N8262A-02

Modification Recommended Service Note

N8262A P-Series Modular Power Meter

Intermittent LAN Connectivity

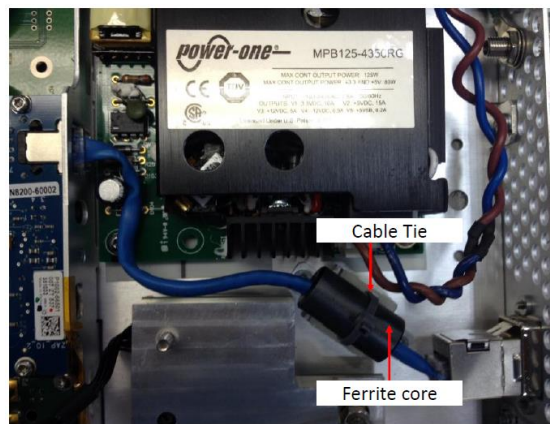
We have received report of some N8262A P-Series Modular Power Meter encountering intermittent connection loss. This has been identified due to the internal LAN cable.

This batch of LAN cable which is made of solid conductor (blue color) is more rigid and resistant to bending. It will be replaced with a new enhanced stranded conductor LAN cable (grey color) which is more flexible and suitable for bending application.

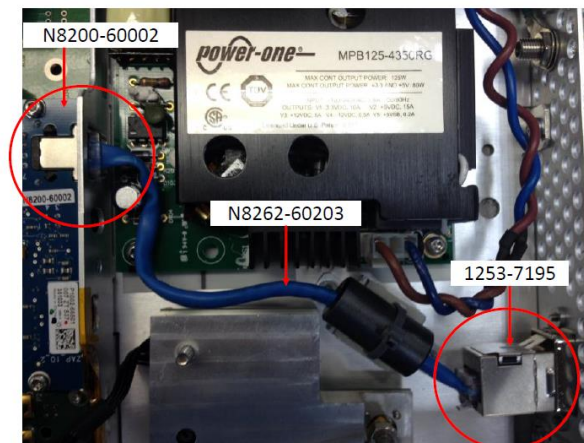
- a) Remove instrument cover accordingly.
- b) Remove the cable tie on ferrite core.

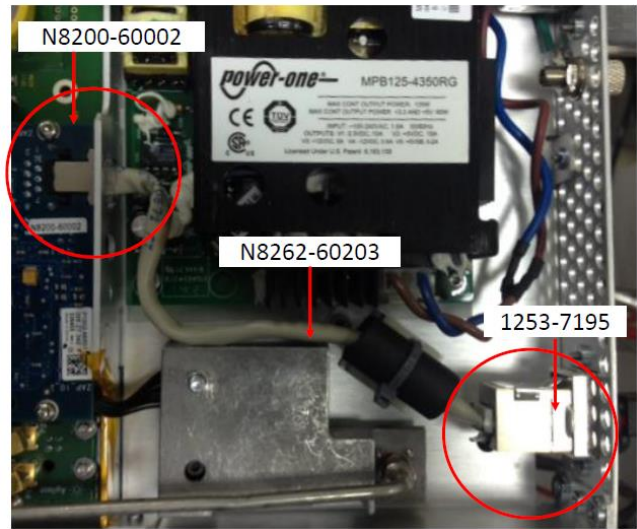
- c) Detached the LAN cable (N8262-60203@blue color) from PPMC Assembly (N8200-60002) and rear panel LAN port (1253-7195).

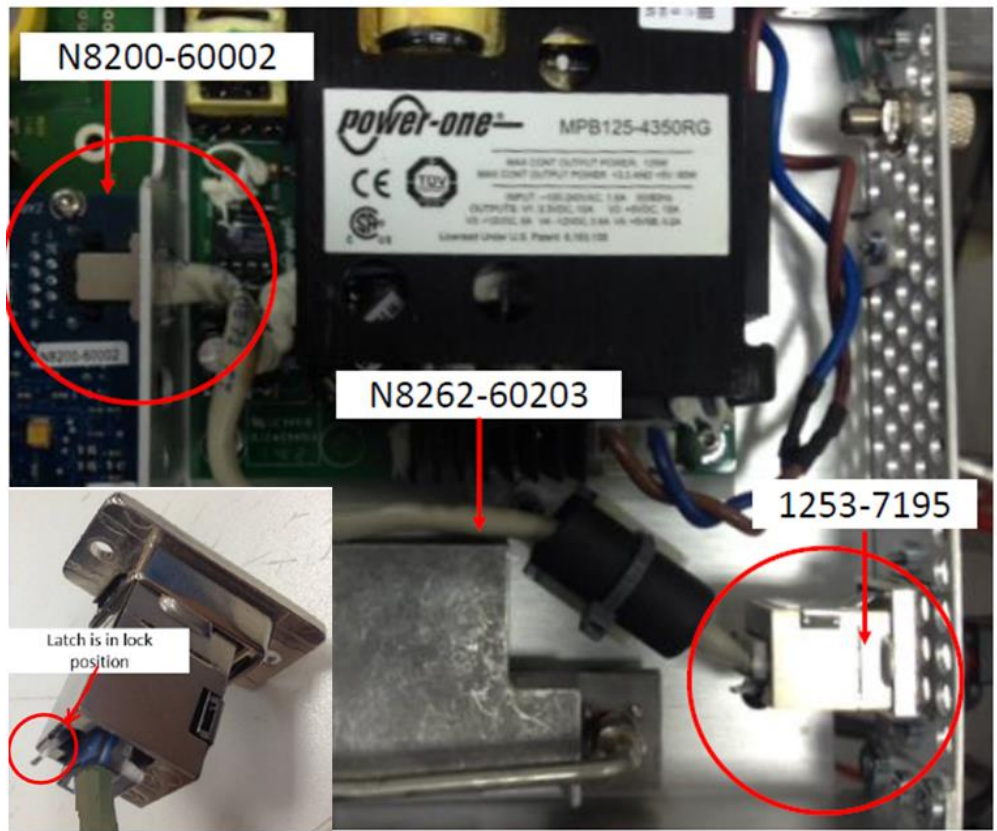
- d) Assemble new LAN cable (N8262-60203@grey color) to PPMC Assembly (N8200-60002) first and then assemble to rear panel LAN port (1253-7195).
- e) Tie ferrite core with cable tie and route cable as shown below.

- f) Ensure LAN cable connection to PPMC Assembly (N8200-60002) and to rear panel LAN port (1253-7195) are latch properly.
